Well Name: FULLER 14/11 B2HA FED COM	Well Location: T26S / R29E / SEC 14 / SENE / 32.0429557 / -103.9484386	County or Parish/State: EDDY / NM
Well Number: 1H	Type of Well: OIL WELL	Allottee or Tribe Name:
Lease Number: NMNM011038	Unit or CA Name:	Unit or CA Number:
US Well Number: 3001553435	Operator: MEWBOURNE OIL COMPANY

Type of Action: APD Change

Procedure Description: Mewbourne Oil Company request that the following changes be made to the approved APD for the Fuller 14/11 B2HA Fed Com #1H (APD ID: 10400080306)... Change well name from Fuller 14/11 B2HA Fed Com #1H to Fuller 14/11 Fed Com #527H Change BHL from 100' FNL & 660' FEL (Sec 11) to 100' FNL & 880' FEL (Sec 11) Request permission for BOP break testing and offline cementing

PECOS DISTRICT DRILLING CONDITIONS OF APPROVAL

WELL LOCATION AND ACREAGE DEDICATION PLAT

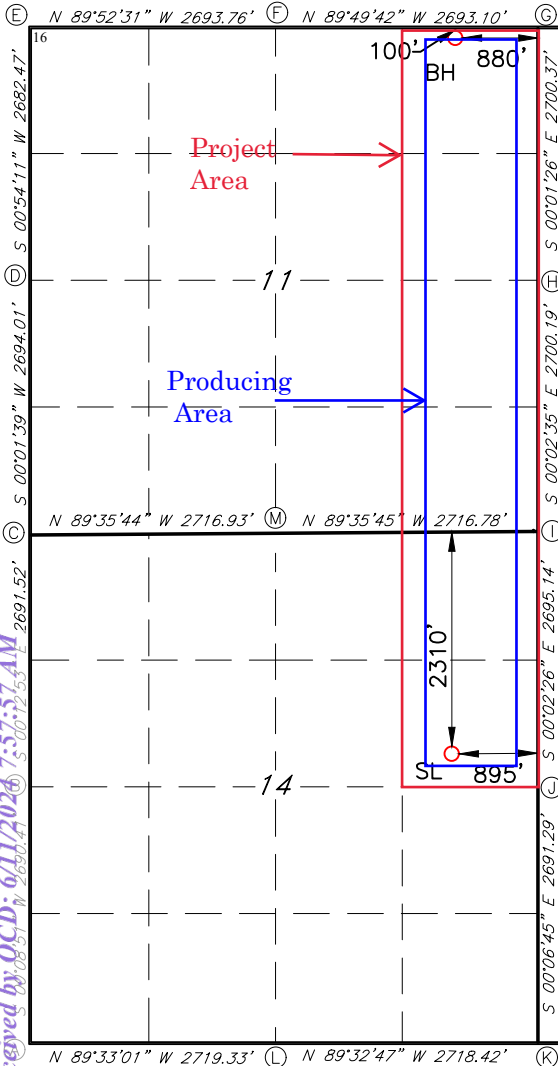
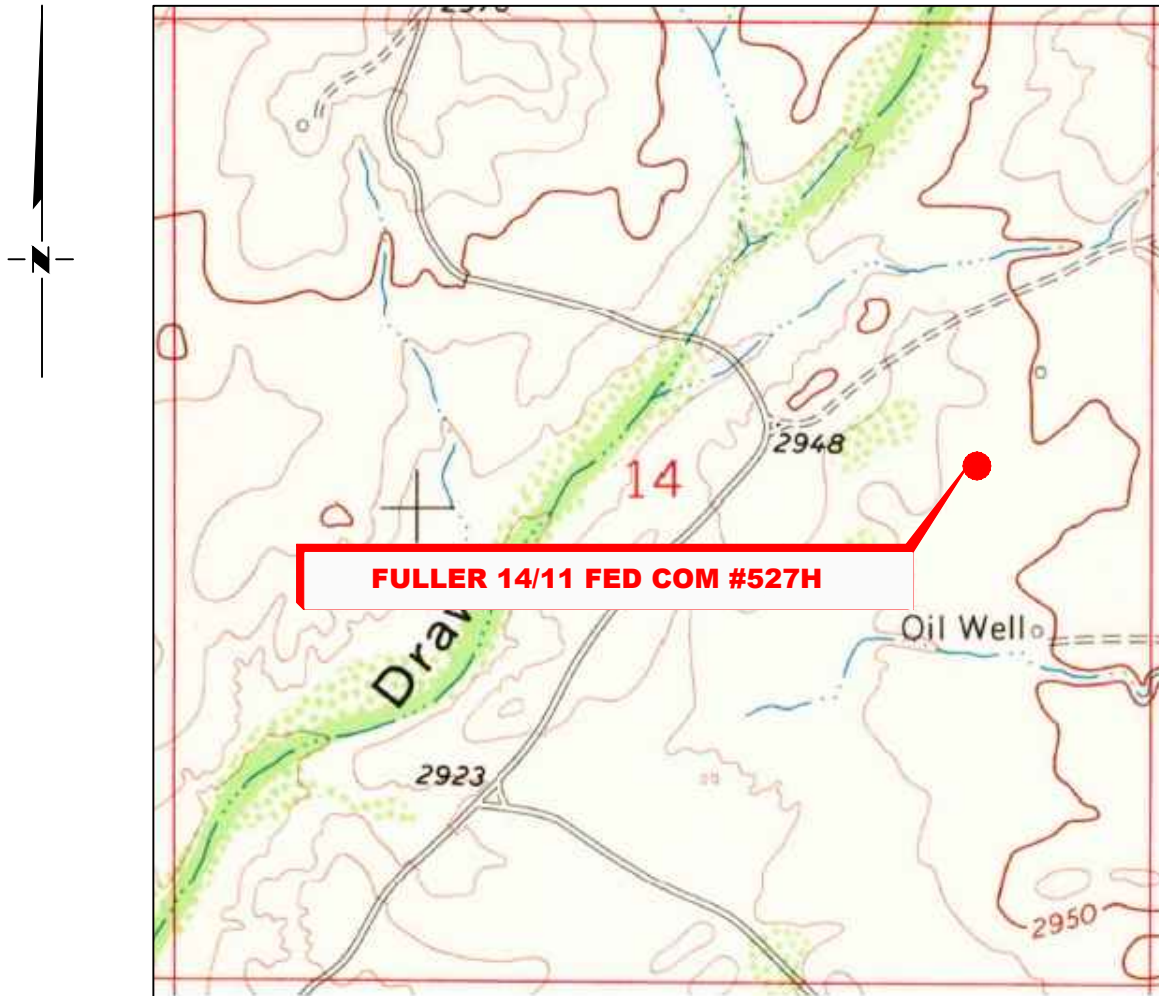
REV: NAME/BH CHANGE-5/16/24

Figure 1. Cactus 13 3/8" 5M offline cementing tool. Pressure rating limited by the lesser of 5M tool rating or the 13 3/8" pup joint and casing.

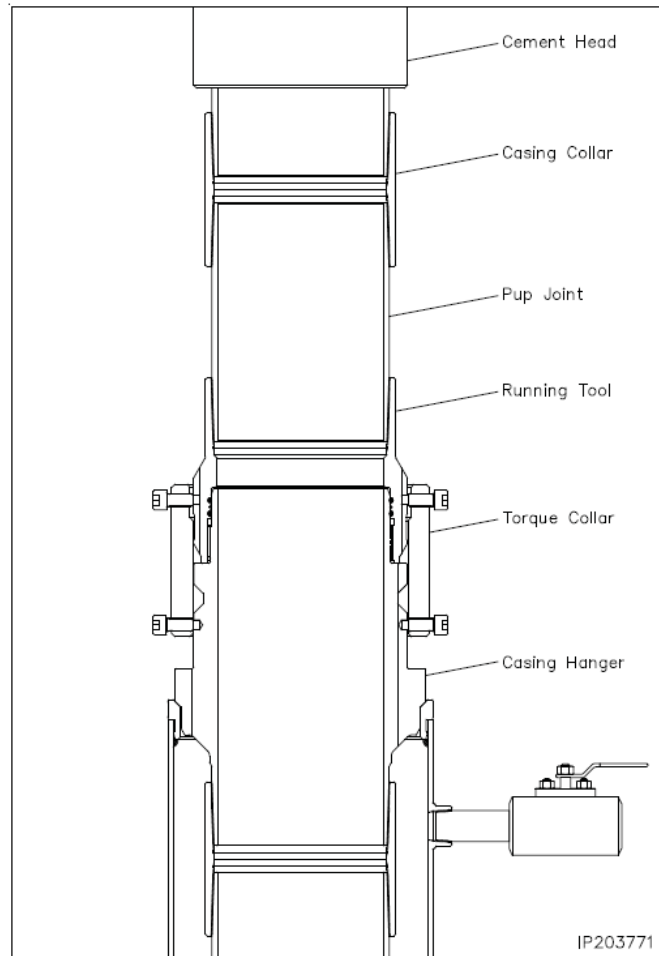
9. Make up offline cement tool with forklift per wellhead manufacturer (Fig. 1 & 2).
10. Make up cement head on top of offline cement tool with forklift.

Operator has been (**Approved**) to pump the proposed cement program offline in the **Surface and intermediate(s) intervals**. Offline cementing should commence within 24 hours of landing the casing for the interval. Notify the BLM 4hrs prior to cementing offline at **Eddy County: 575-361-2822**.

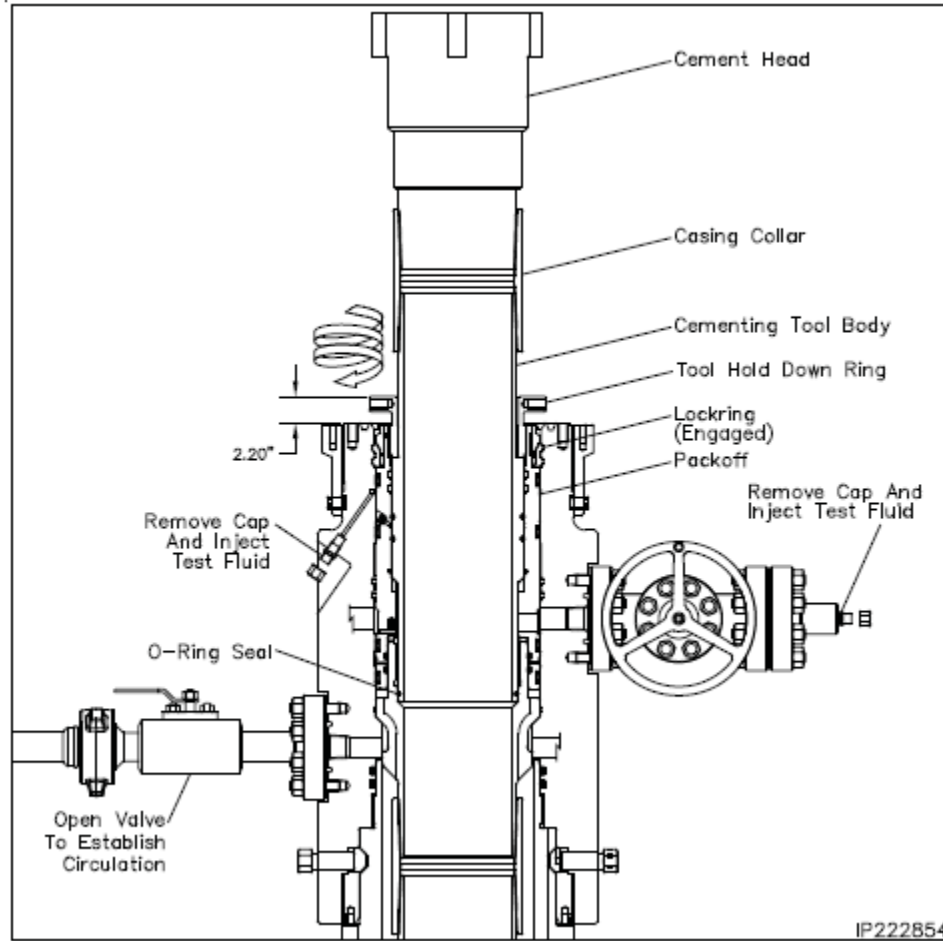
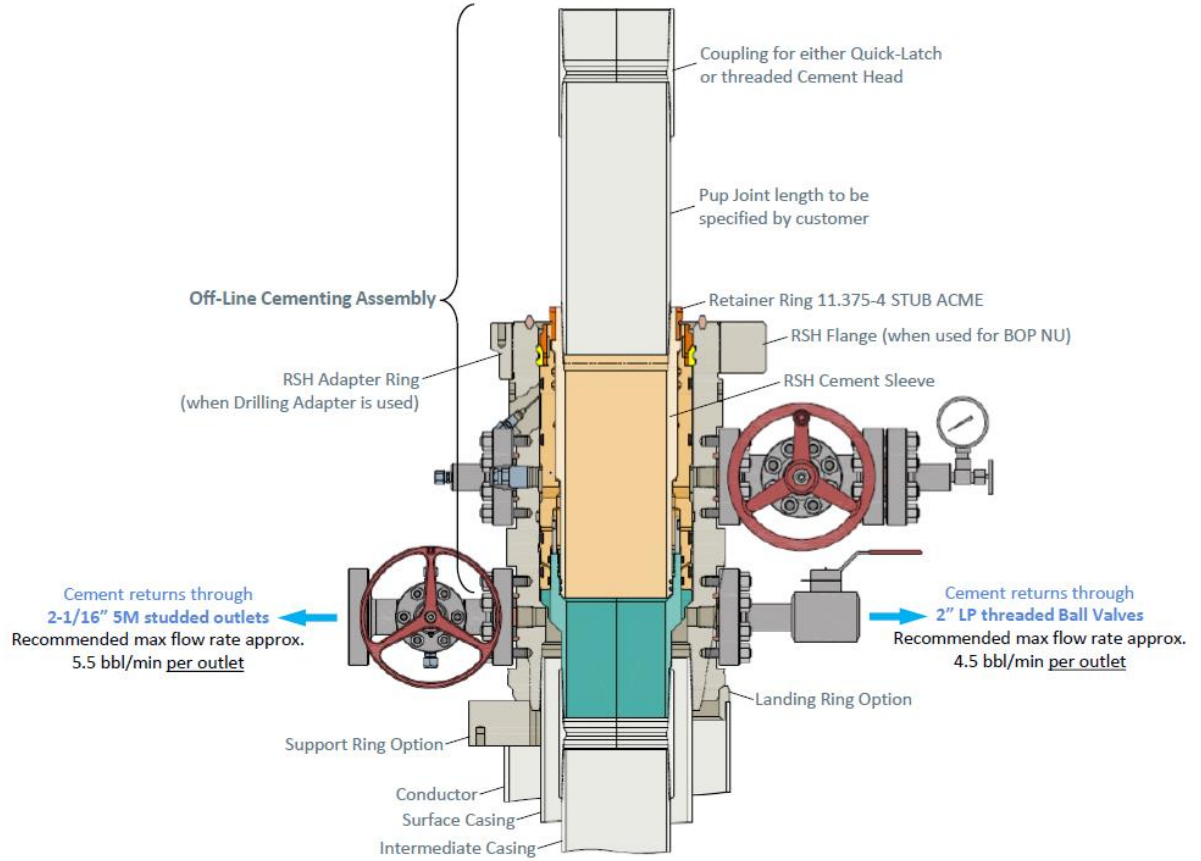
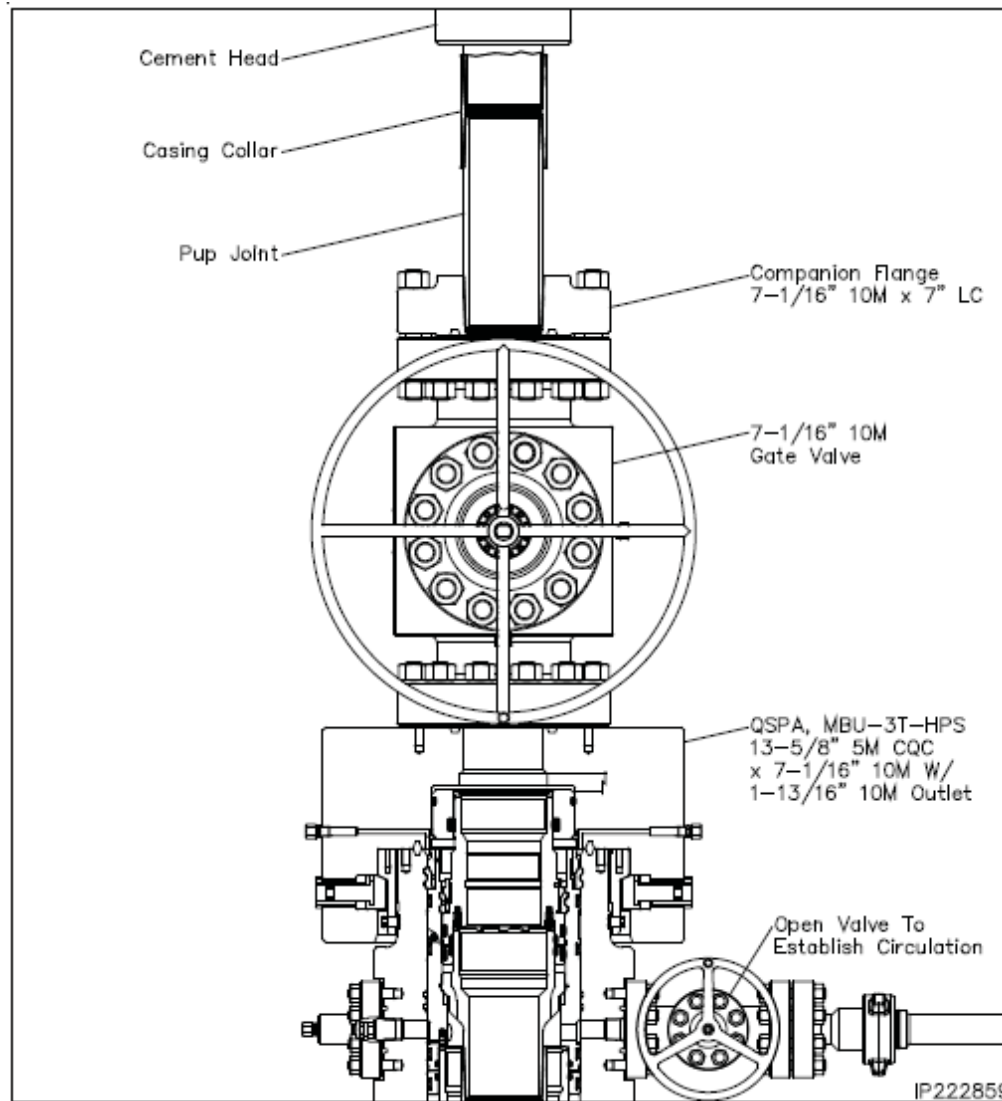
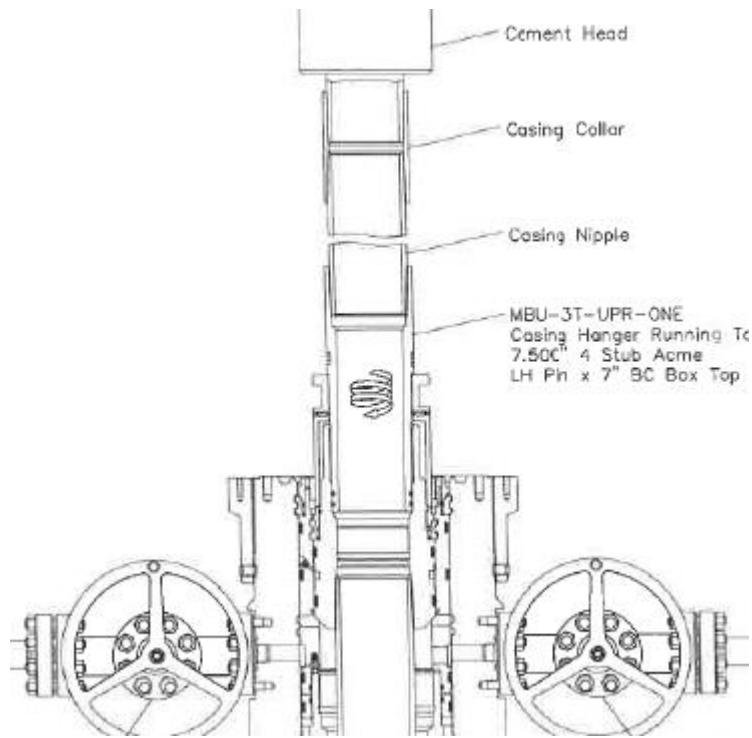
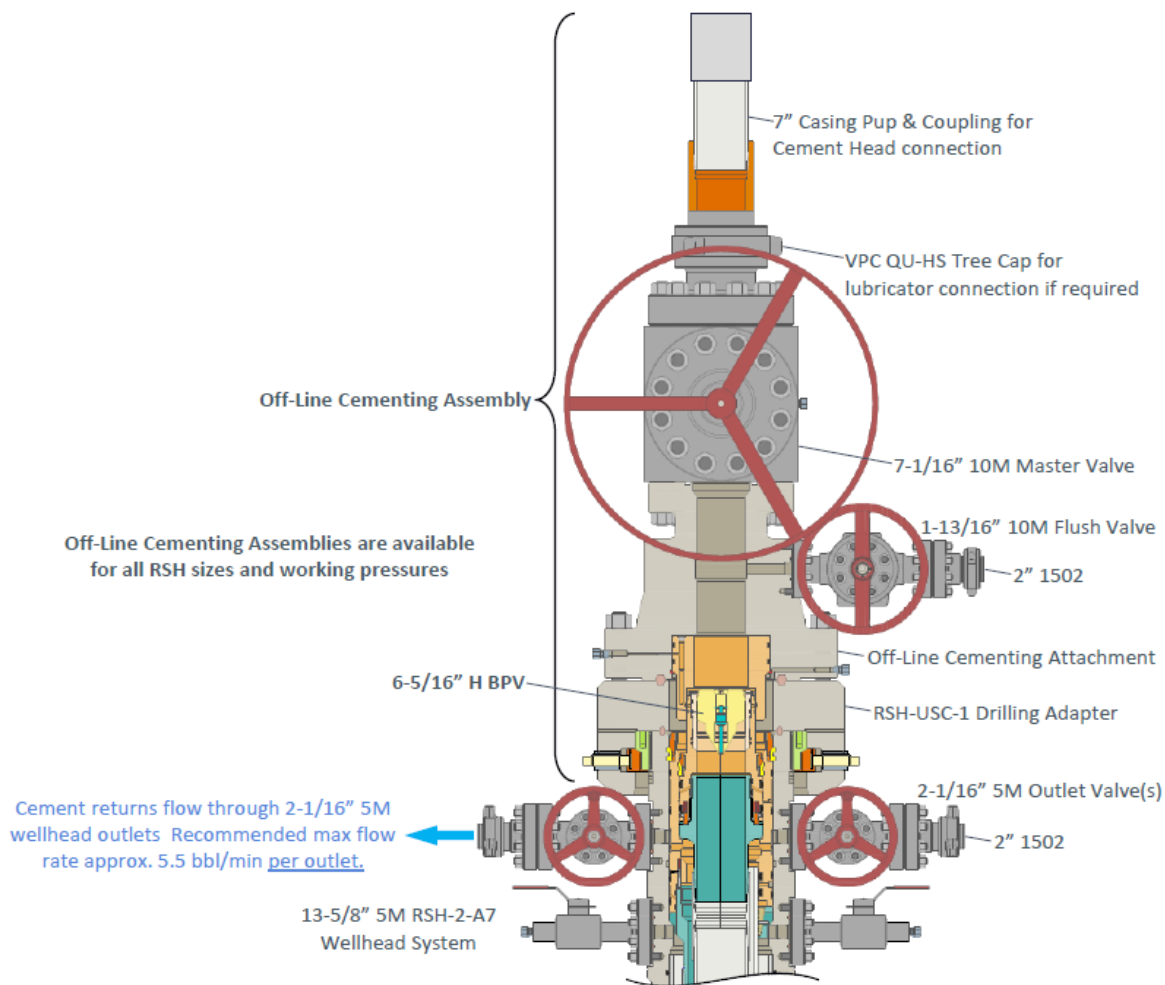
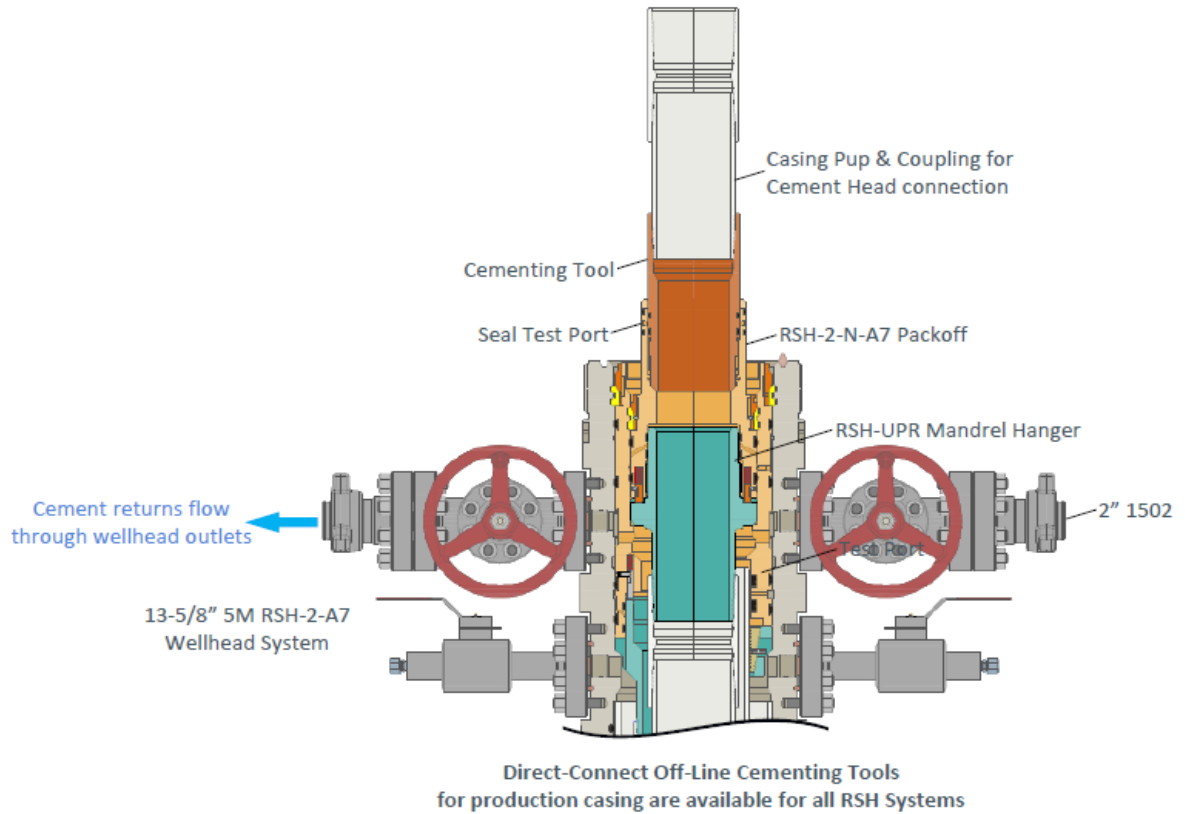
10. Make up offline cement tool using forklift per wellhead manufacturer (Fig. 3 - 8).
11. Make up cement head on top of offline cement tool.
12. Commence cement operations.

Figure 1. BOP diagram

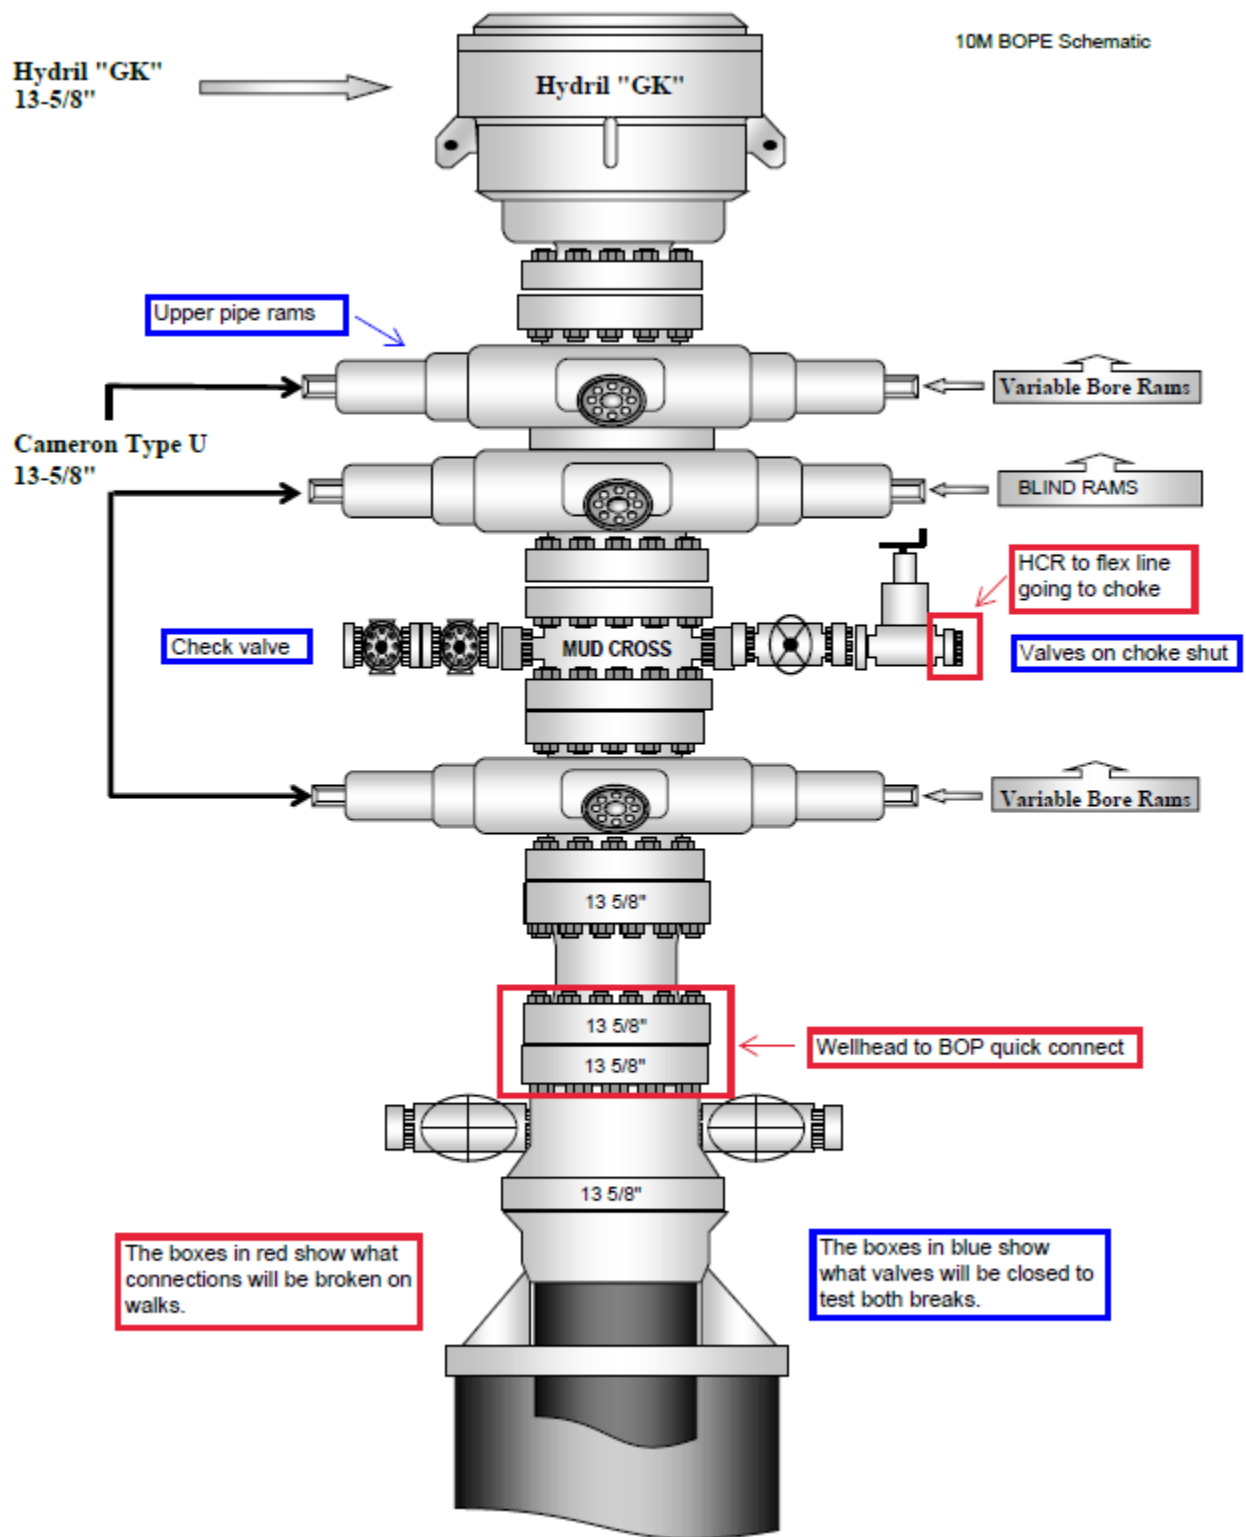
2. After the well section is secured and the well is confirmed to be static, the BOP will be disconnected from the wellhead and walked with the rig to another well on the pad. Two breaks on the BOPE will be made (Fig. 1).

9. A test will then be conducted against the upper pipe rams and choke, testing both breaks (Fig. 1 & 2).
10. The test will be held at 250 psi low and to the high value submitted in the APD, not to exceed 5000 psi.

- BOPE Break Testing is ONLY permitted for 5M BOPE or less. **(Annular preventer must be tested to a minimum of 70% of BOPE working pressure and shall be higher than the MASP)**
- BOPE Break Testing is NOT permitted to drilling the production hole section.
- Variance only pertains to the intermediate hole-sections and no deeper than the Bone Springs formation.
- While in transfer between wells, the BOPE shall be secured by the hydraulic carrier or cradle.
- Any well control event while drilling require notification to the BLM Petroleum Engineer **(575-706-2779)** prior to the commencement of any BOPE Break Testing operations.
- A full BOPE test is required prior to drilling the first deep intermediate hole section. If any subsequent hole interval is deeper than the first, a full BOPE test will be required. (200' TVD tolerance between intermediate shoes is allowable).

- The BLM is to be contacted (**575-361-2822 Eddy County**) 4 hours prior to BOPE tests.
- As a minimum, a full BOPE test shall be performed at **21**-day intervals.
- In the event any repairs or replacement of the BOPE is required, the BOPE shall test as per **43 CFR part 3170 Subpart 3172**.
- If in the event break testing is not utilized, then a full BOPE test would be conducted.
